DECISION OF THE PLANNING ADMINISTRATOR

**SUBDIVISION TENTATIVE PLAN / URBAN GROWTH PRELIMINARY
DECLARATION / CLASS 3 SITE PLAN REVIEW / CLASS 2 ADJUSTMENT /
TREE VARIANCE / CLASS 1 DESIGN REVIEW CASE NO.: SUB-UGA-SPR-ADJ-
TRV-DR23-02**

APPLICATION NO.: 22-119071-PLN

SUMMARY: A proposed six-lot subdivision for Titan Hill Estates in conjunction with a proposed multi-family development of 436 units for Titan Hill Apartments.

SDR3

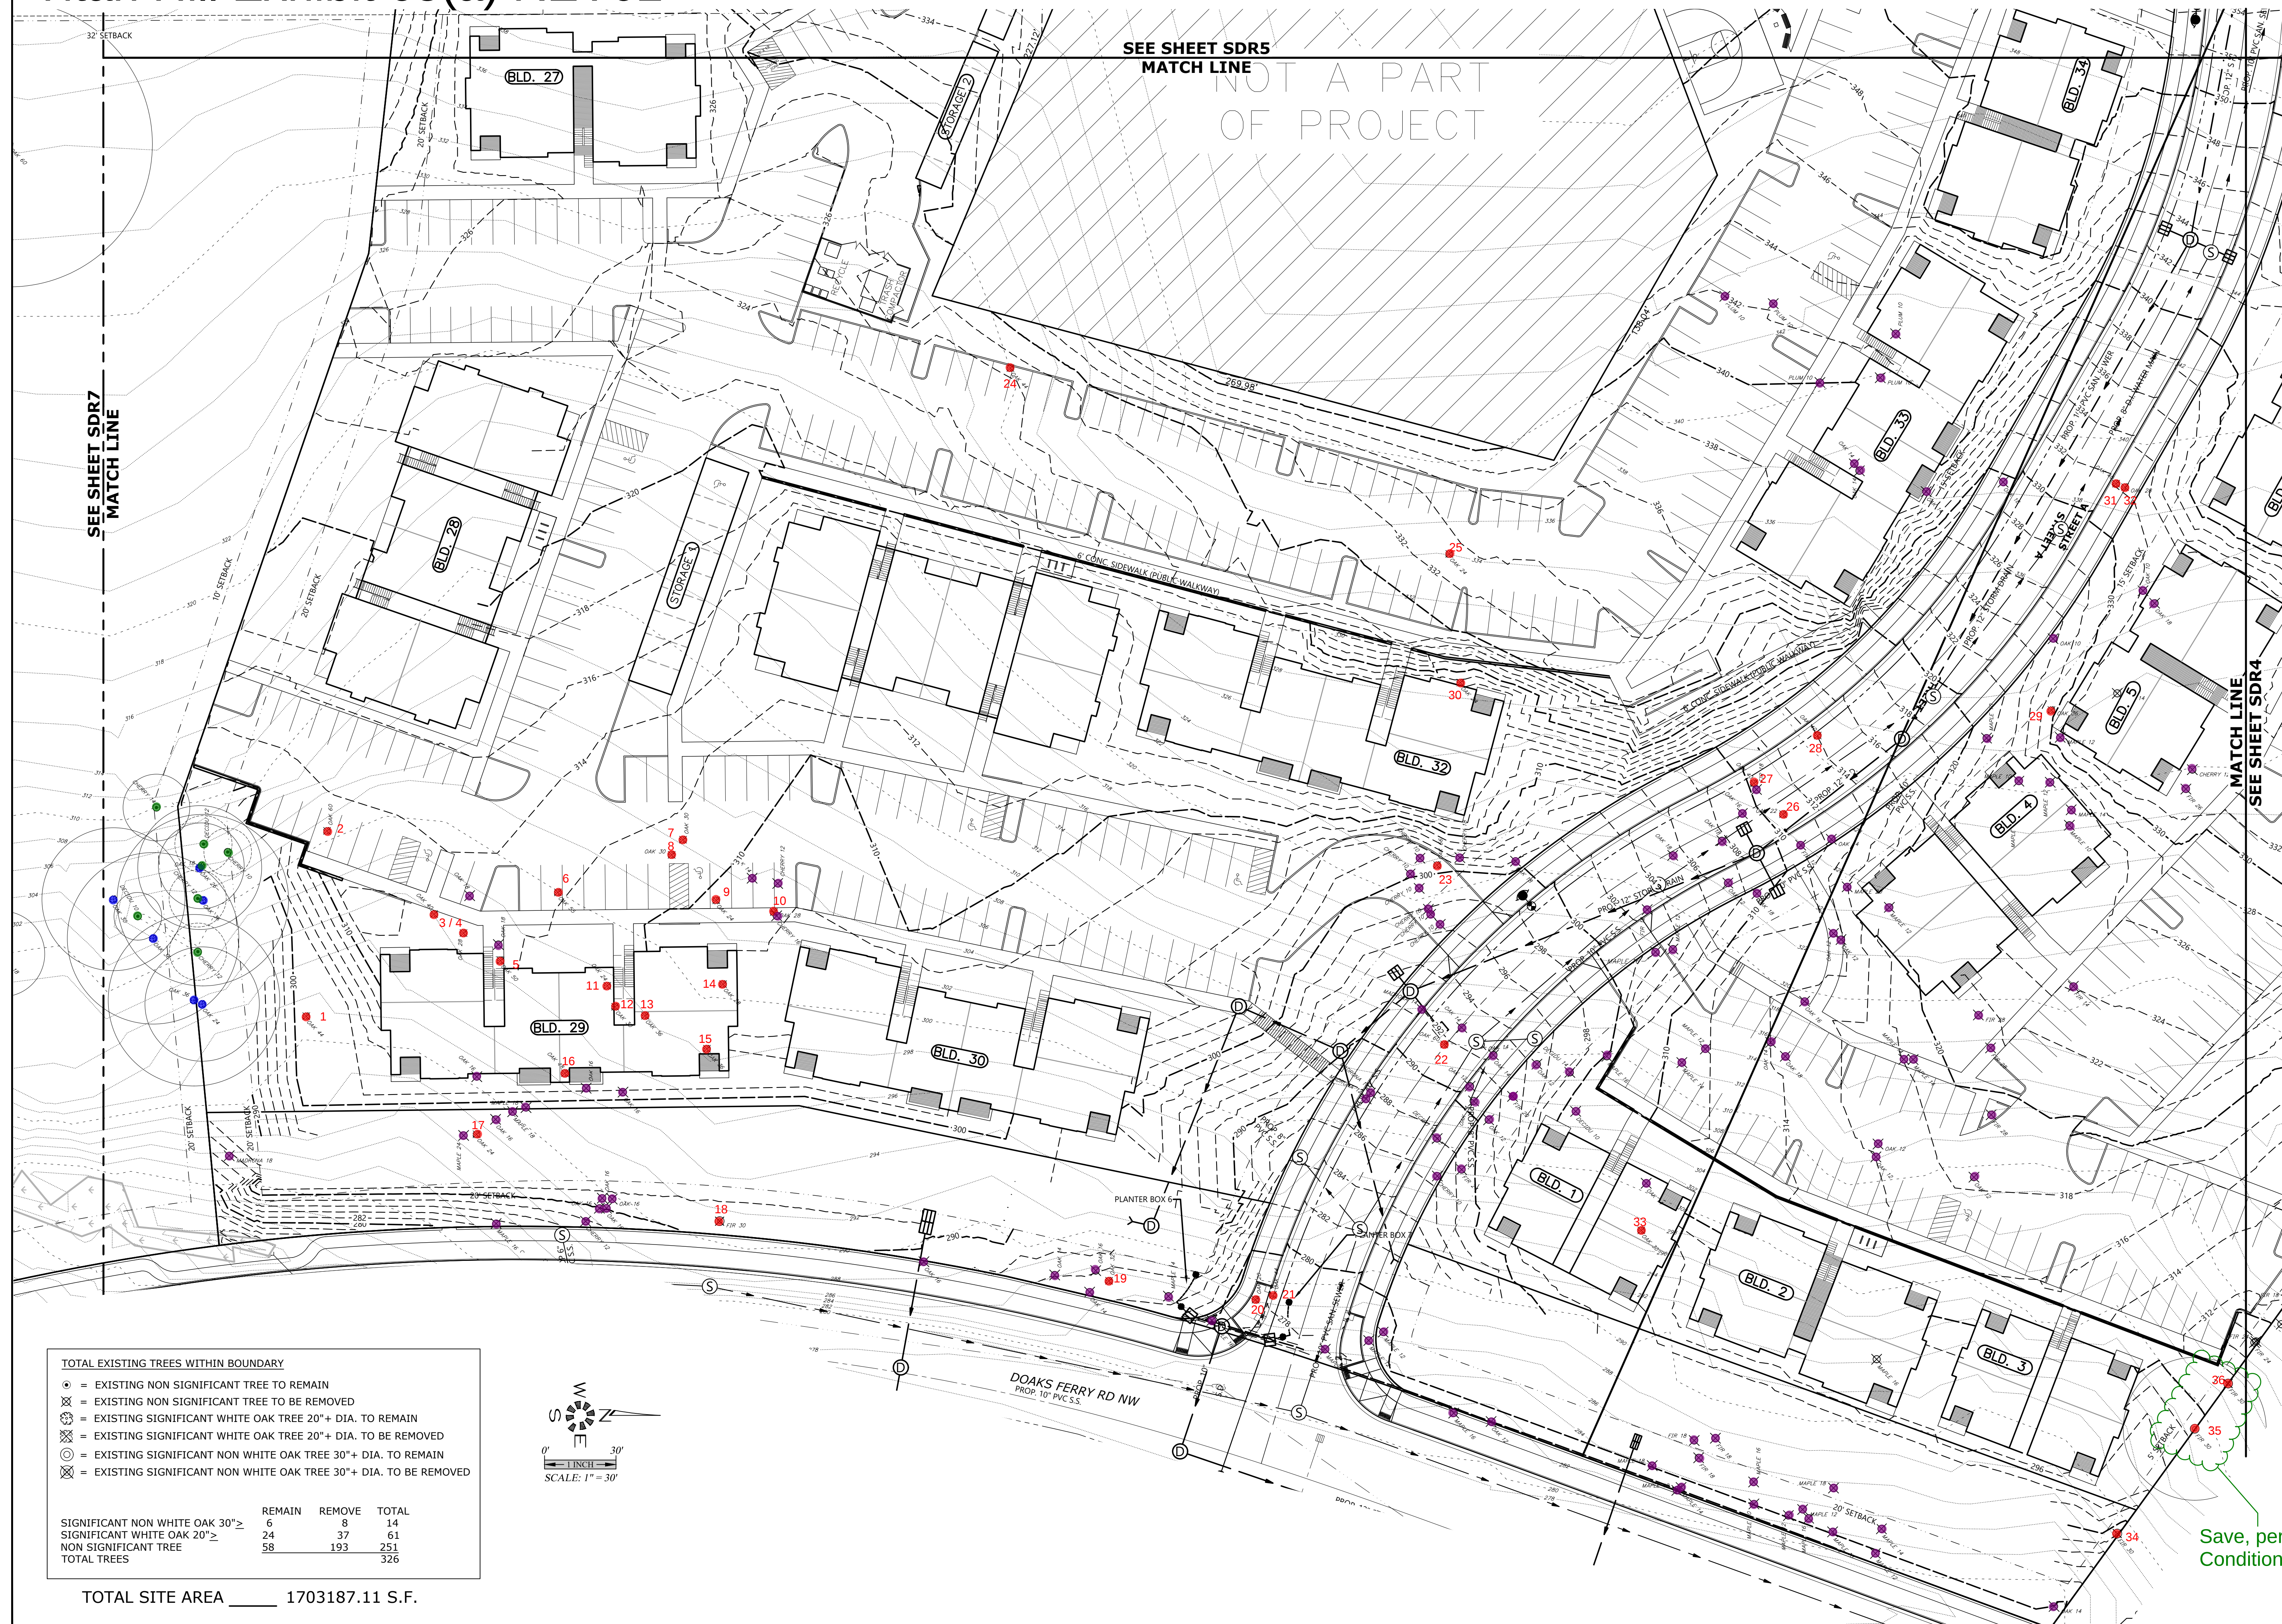
Save, per
Condition 55

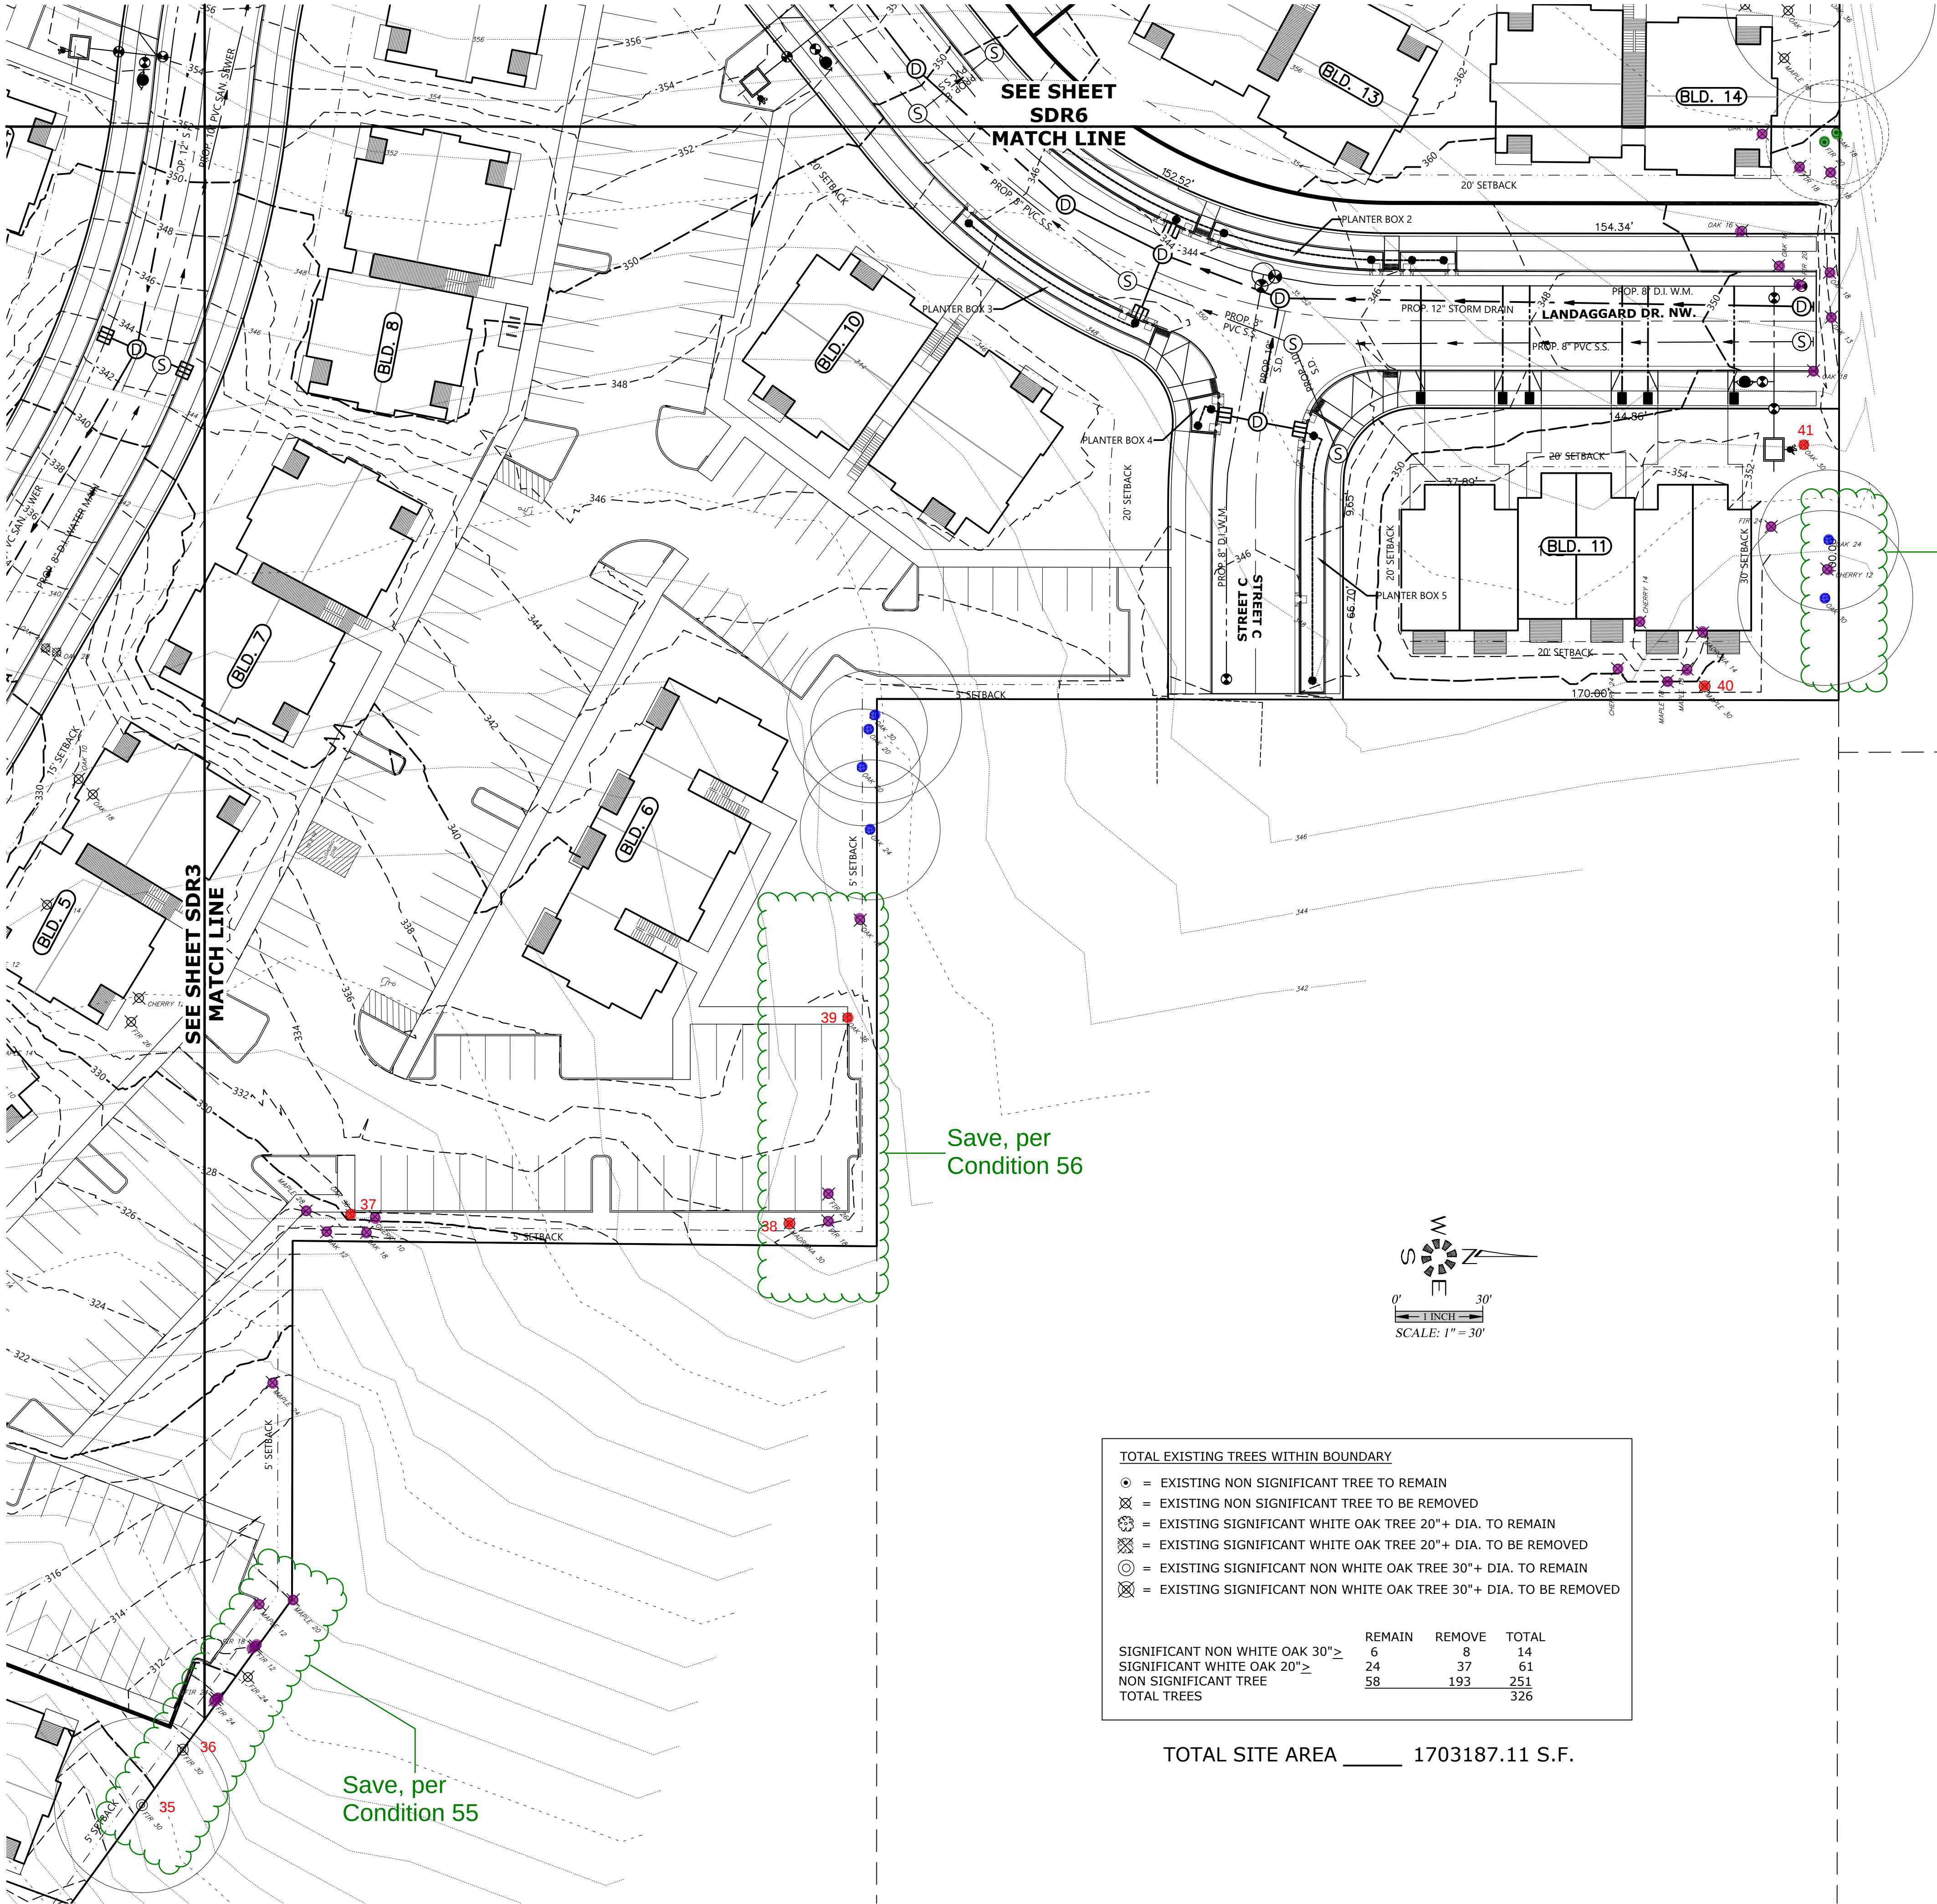
Save, per Condition 56

Save, per Condition 55
